# Murphy Creek

## General Development Plan

### Amendment No. 3

Change Land Use in PA-9C from P.D. Commercial to S.F.A. (TWN.) or S.F.D. Small. No change in dwelling units permitted.

Sheet 1 of 5

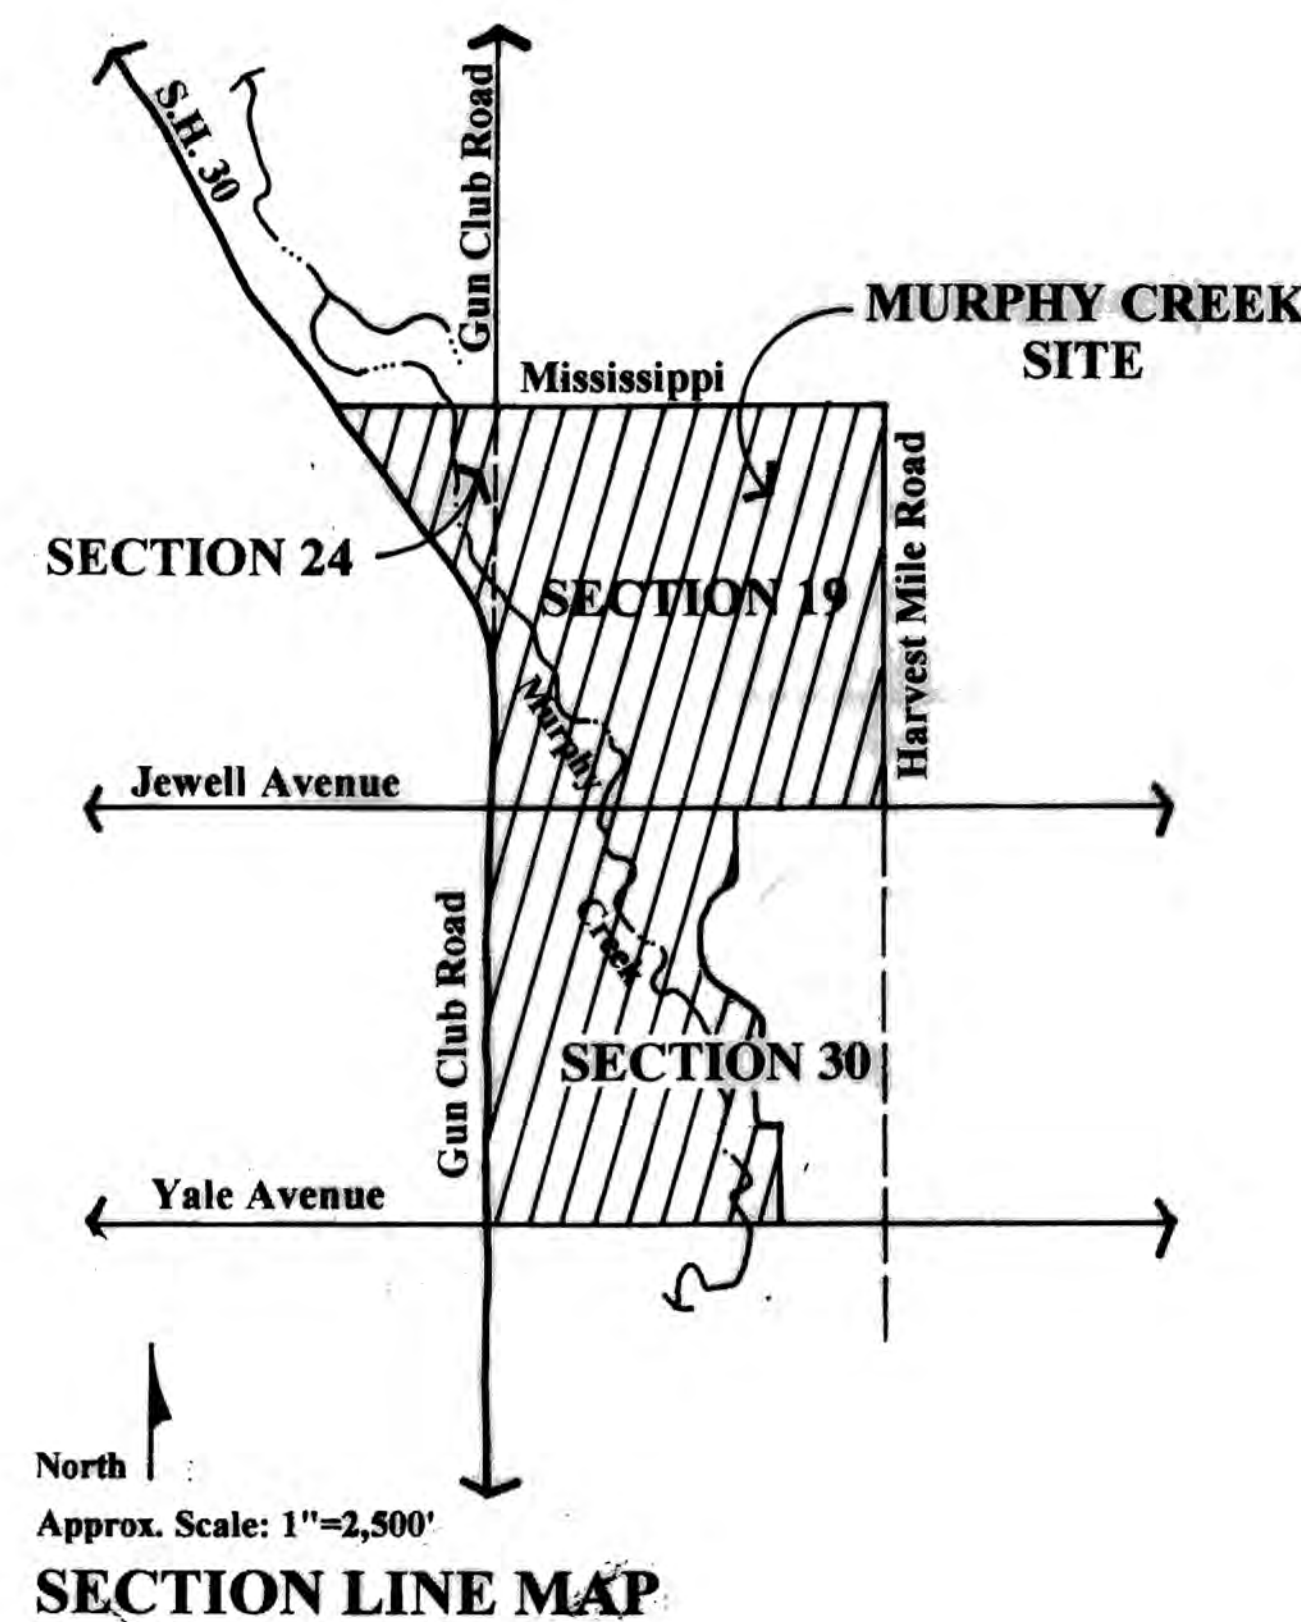
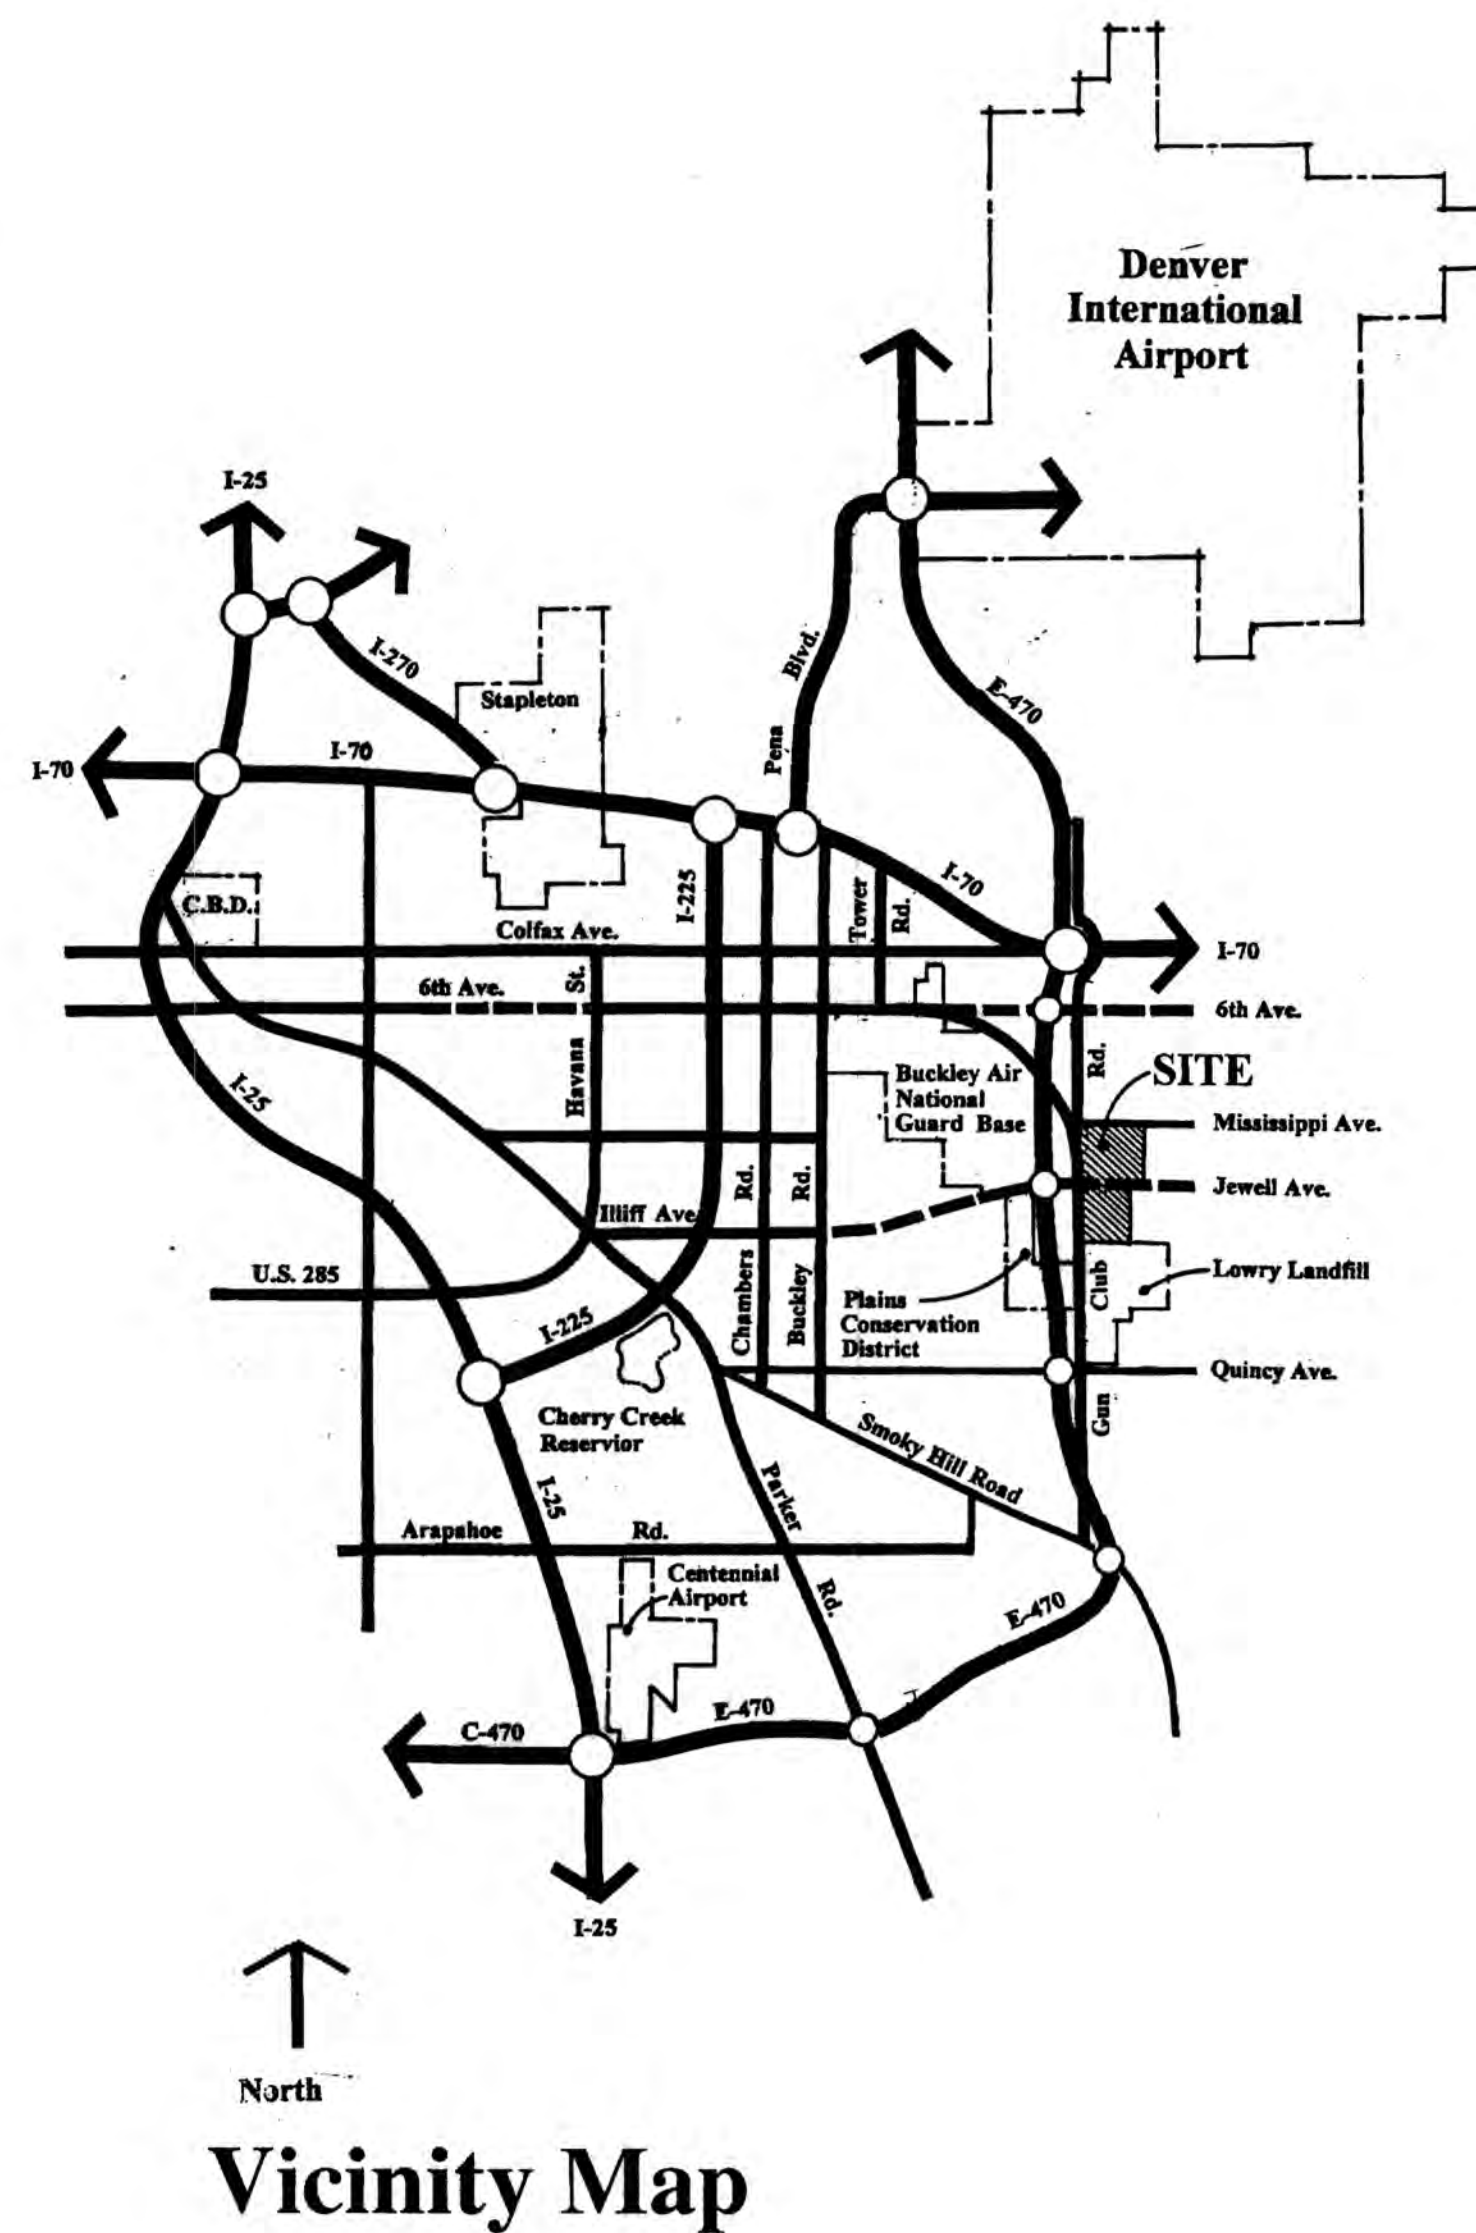
Zante Street north of E Montana Place and south of S Gun Club Road (just south of 1c, G) is changed to align with current (2024) Aurora street criteria and is planned to be a modified two lane collector with a 65.5' ROW.

Sheet 3 of 5

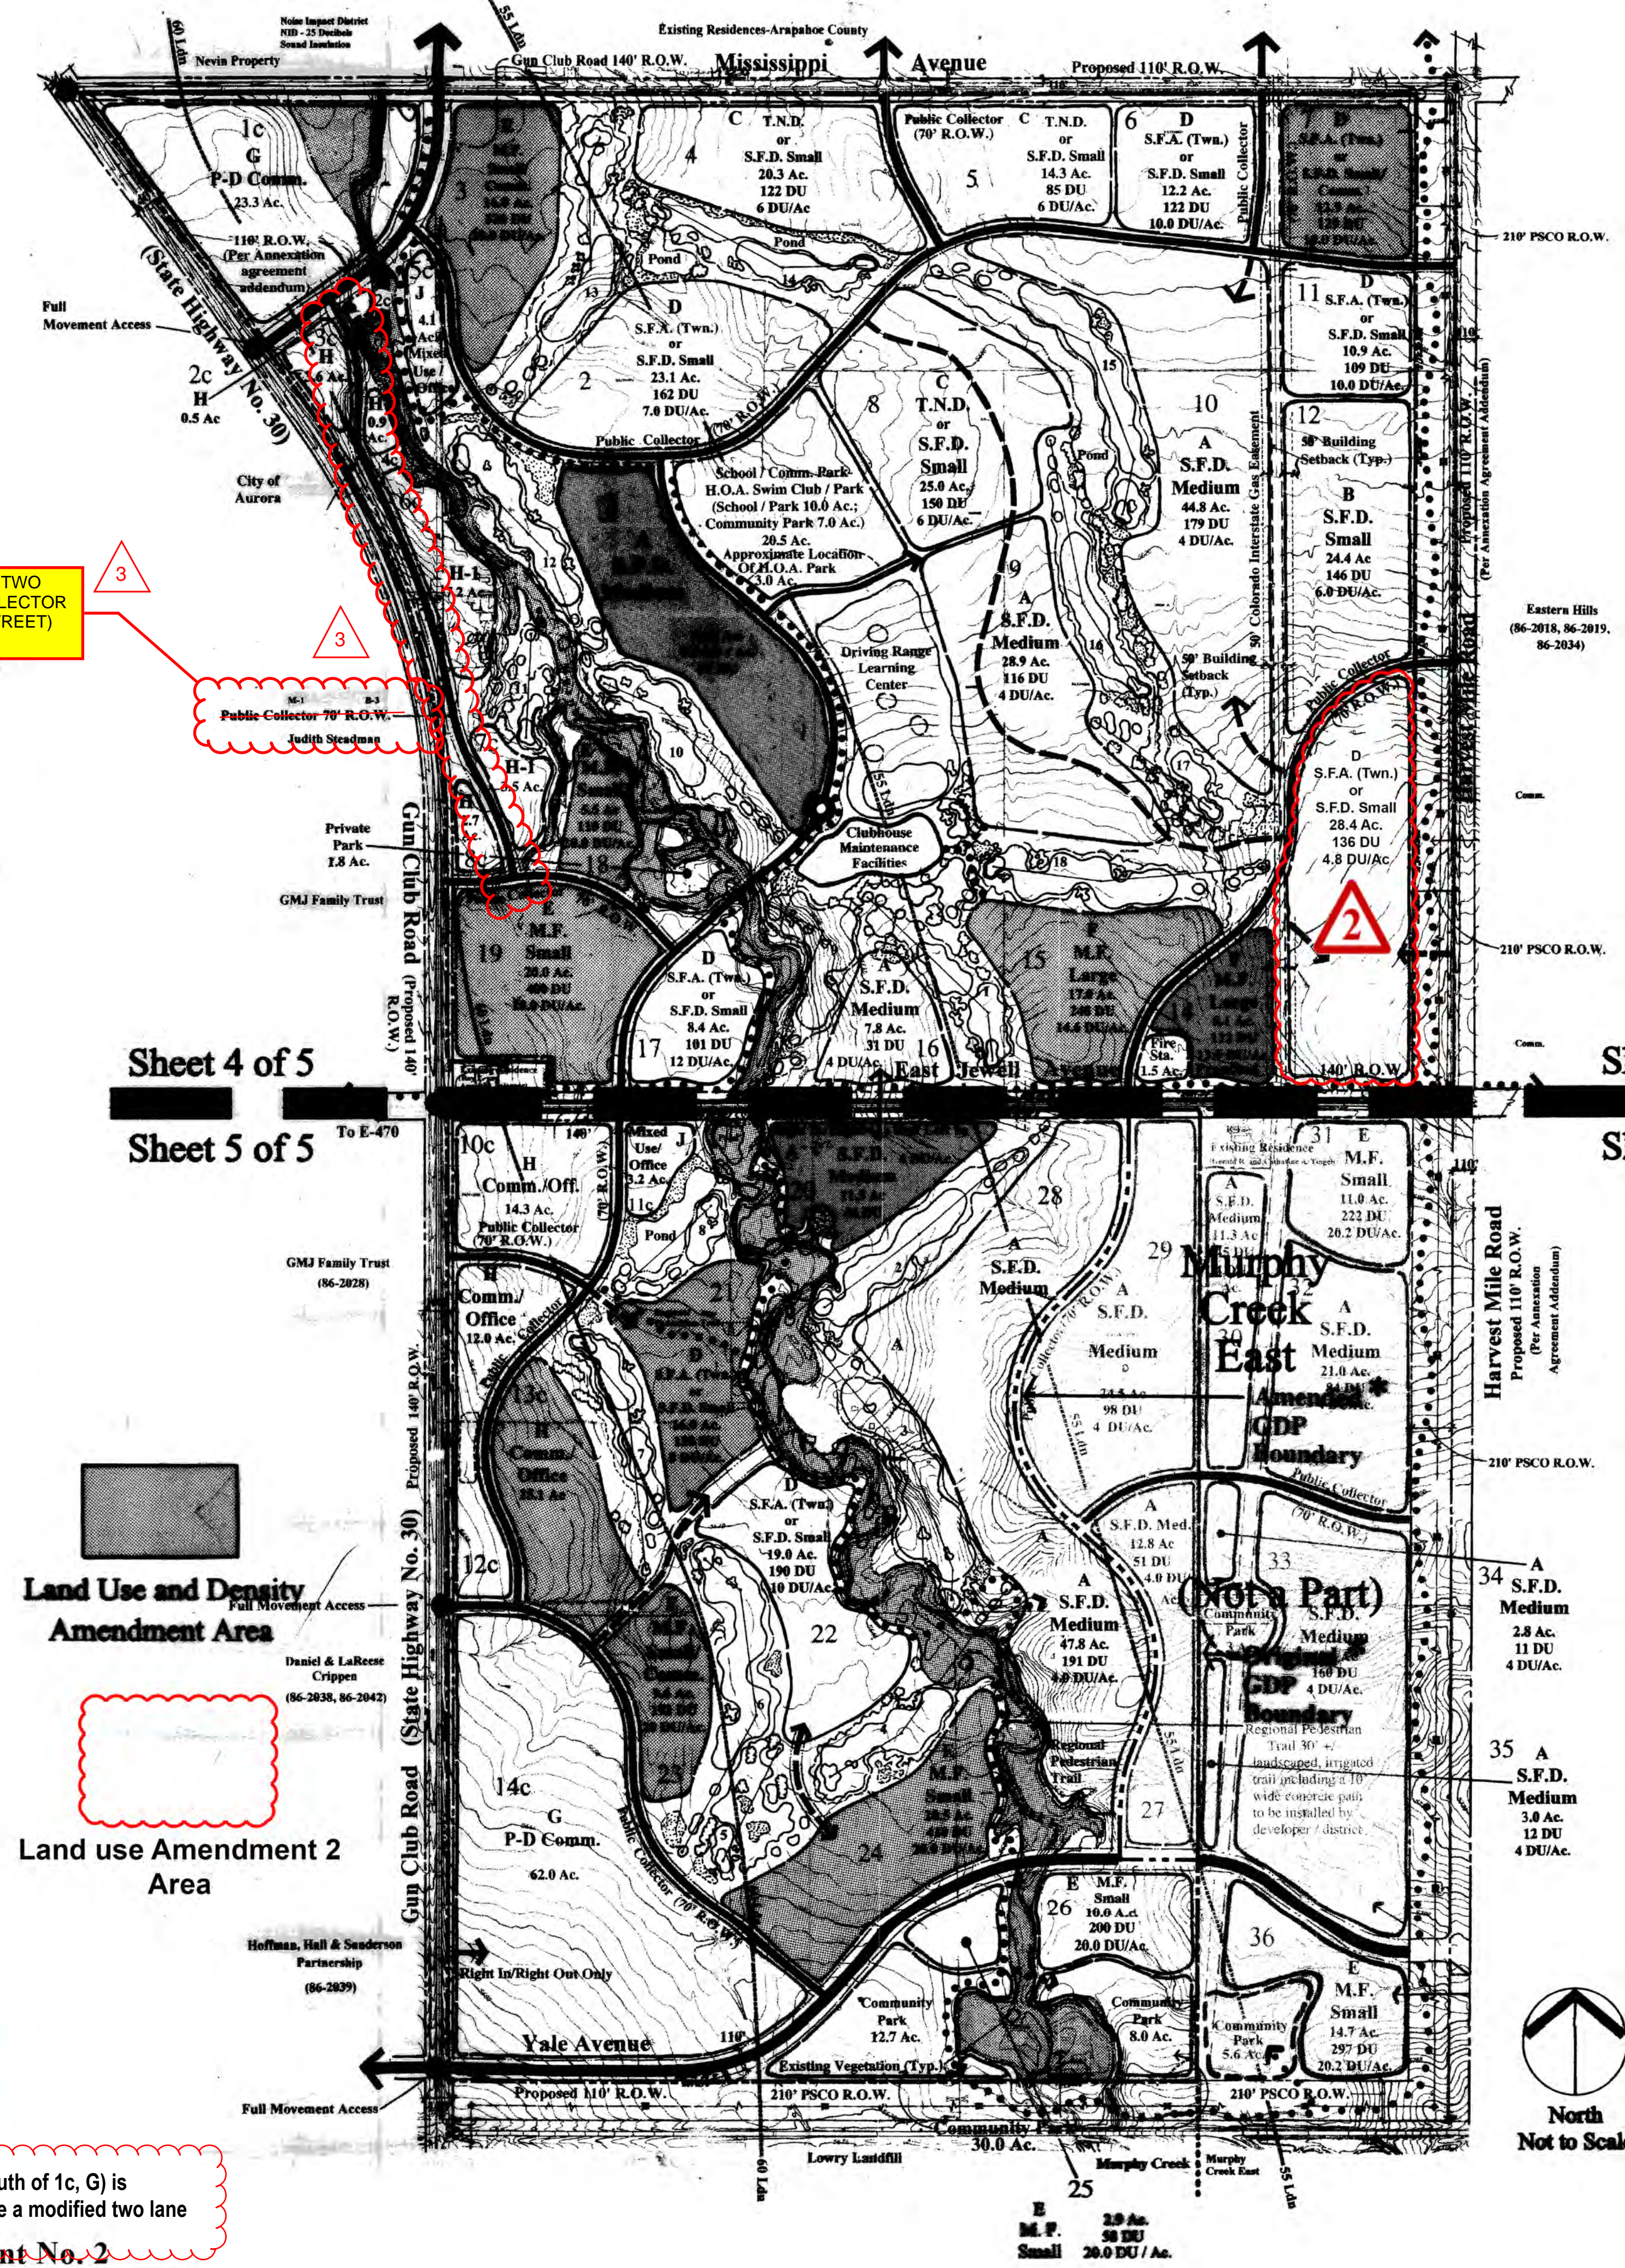
Change Land Use in PA-9C from P.D. Commercial to S.F.A. (TWN) or S.F.D. Small. No change in dwelling units permitted.

Zante Street north of E Montana Place and south of S Gun Club Road (just south of 1c, G) is changed to align with current (2024) Aurora street criteria and is planned to be a modified two lane collector with a 65.5' ROW.

MODIFIED TWO LANE COLLECTOR (ZANTE STREET) 65.5' ROW

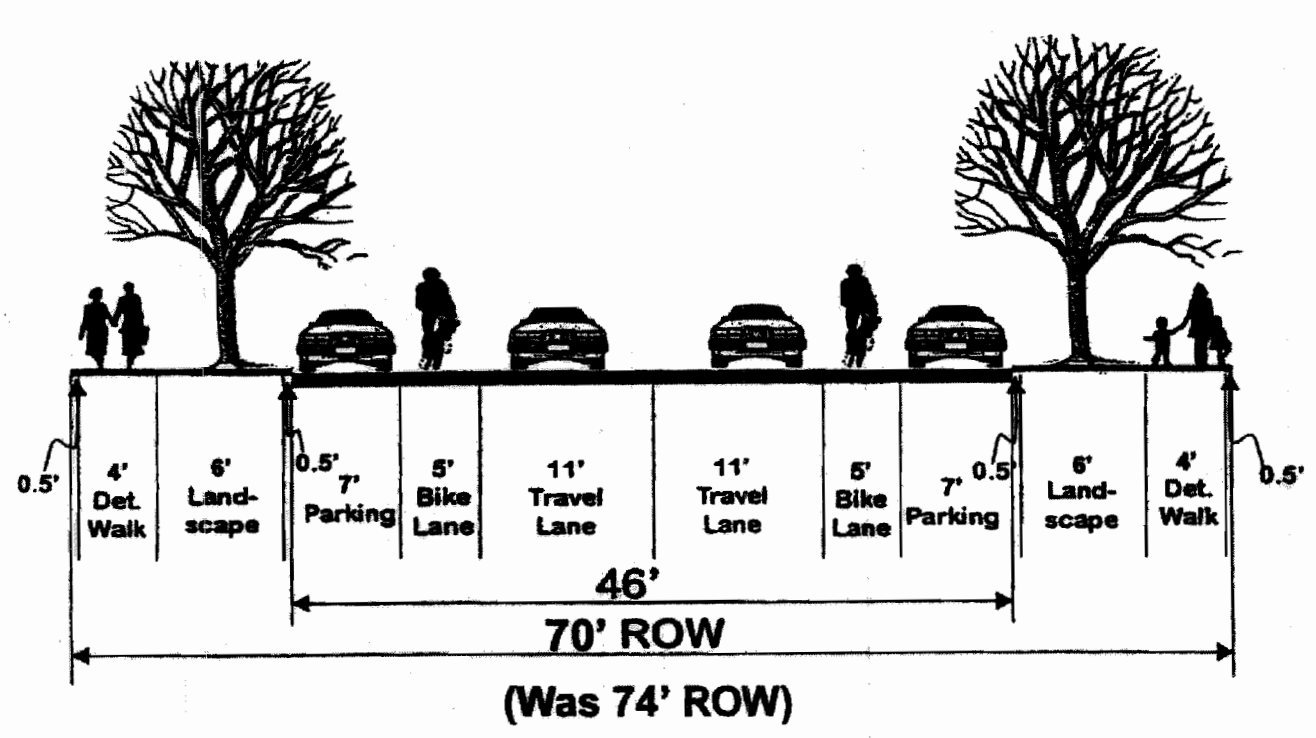
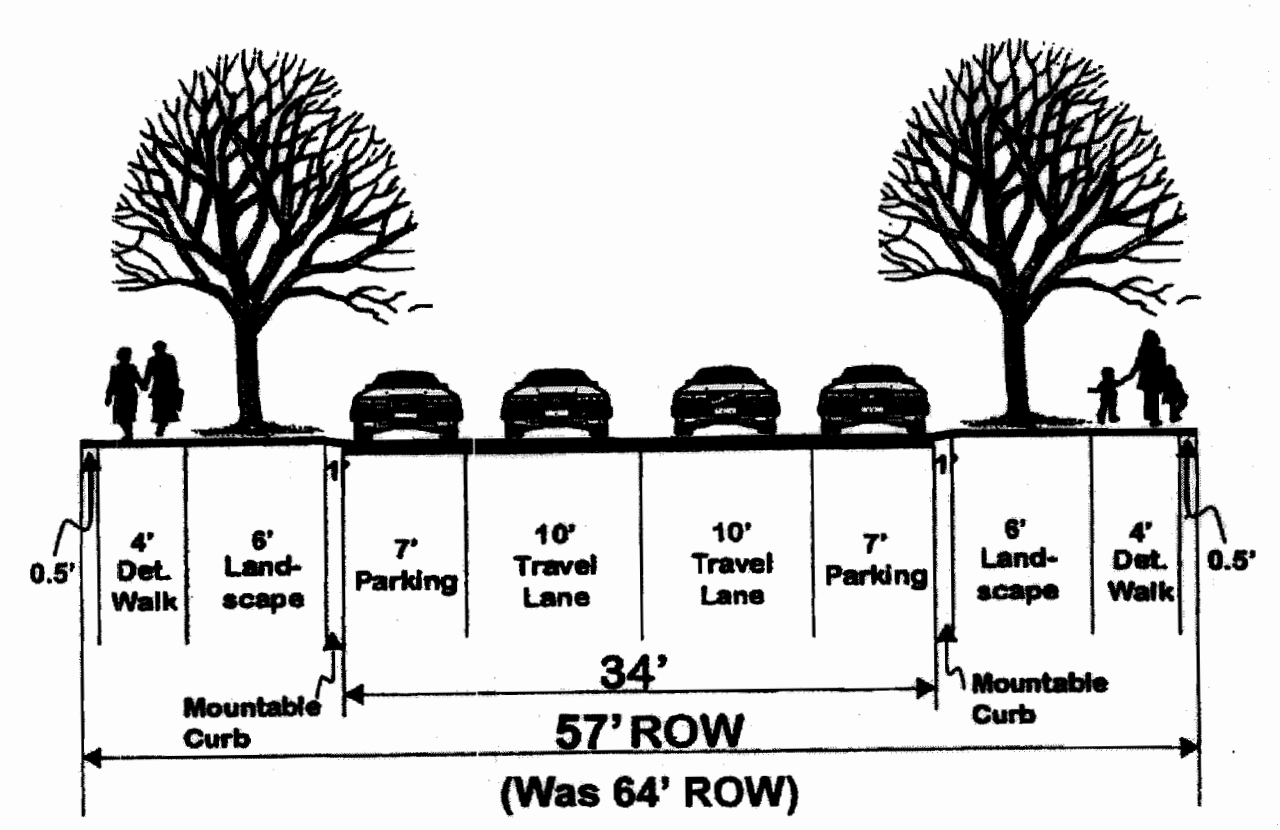
FOR THIS AMENDMENT, ZANTE WILL HAVE A MODIFIED AURORA STANDARD SECTION

Note: Curb & gutter is standard 6" vertical with 2 foot gutter.
